SIGTP-03_observation period of no TP

Observation Time of No Thermal Propagation

Scenario 1:

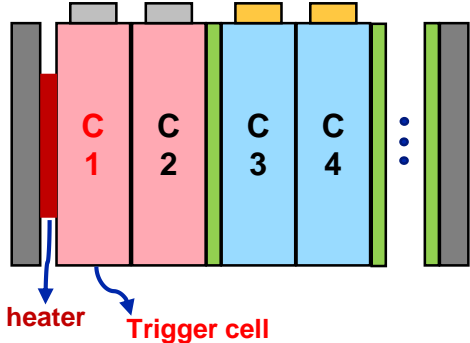
Does the sequential occurrence of thermal runaway imply that in addition to the initiation cell, at least two cells should enter TR?
